From: [Michelle Kuehn](#)
To: [Planning Commission](#)
Subject: Angelo Consentino - County File Number: PLN2024-00327
Date: Tuesday, March 11, 2025 1:42:37 PM
Attachments: [Morria Shaffer Engineering.pdf](#)

RE: Rear property line retaining wall
2897 Adeline Drive, Burlingame, CA

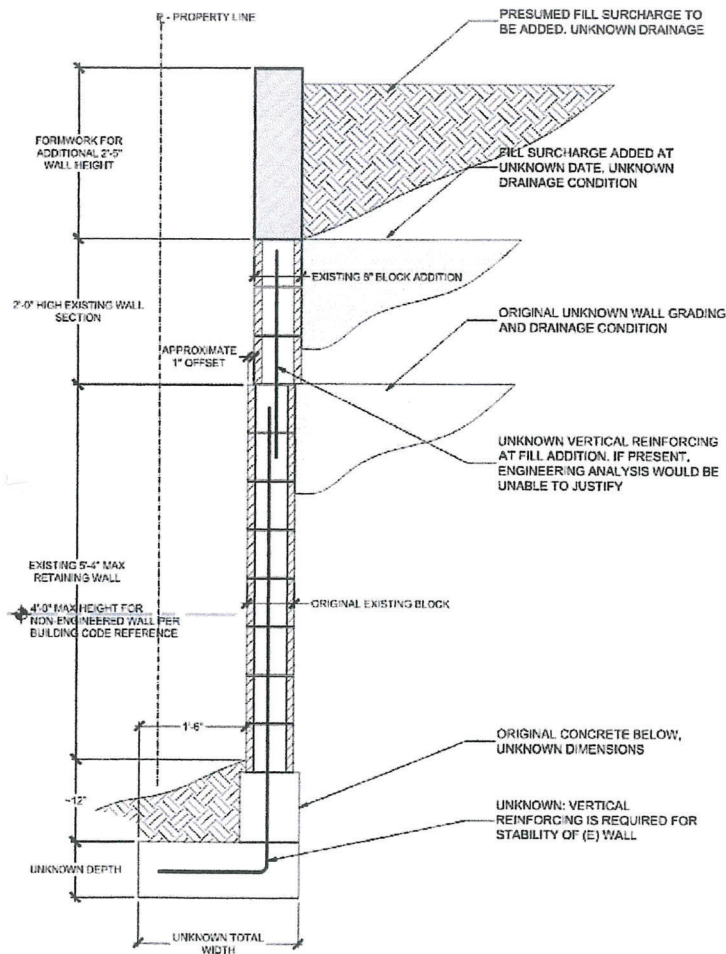
We noted an existing concrete block wall built in two phases. An original lower portion extending approximately 5'-4" above the low grade at the subject property and a 2'-0" extension above the original wall. See Figure 2 and Photo 1. It is the owner's recollection that original retaining wall is at least 40 years old. We were unable to verify the age of either segment of the wall, but the estimated age is reasonable based on our visual review. A portion of the soil at the toe of the wall was excavated to verify the foundation dimensions which extends horizontally 18" from the front face of the wall. (See Photo 2 on next page). There was no documentation available for the wall construction, thus the drainage, reinforcing and grout for the block wall, and the depth and reinforcing of the wall foundations are unknown.

It is unlikely that either segment of the existing wall was engineered. The California Building Code requires all walls over 4' high measured from the bottom of the foundation to be engineered, thus the existing wall is non-conforming. We noted the presence of formwork that has been added to the top of this non-conforming wall. We understand this has been added in the course of construction initiated by the owners at the 2896 Hillside Drive property and this will potentially create a retained soil height over 9'-6".

It is our opinion that the existing wall condition is already inadequate for the retained condition present. In Photo 1 there is evidence that water may be seeping through the block grout at the middle joint which over time will break down the wall. The addition to its height will exacerbate the visible movement at the joint between the original block wall and extension. Many jurisdictions limit retained wall heights to 6'-0" to minimize the imposition of downhill site condition. We did not confirm if the local zoning codes include such restrictions, but note that where they are implemented, it is to restrict property owners from creating conditions such as the one this construction will create. It is our opinion that construction of the wall extension at the 2896 Hillside Drive property should be halted until engineering work has been done to justify its construction and zoning codes reviewed concerning the maximum height.
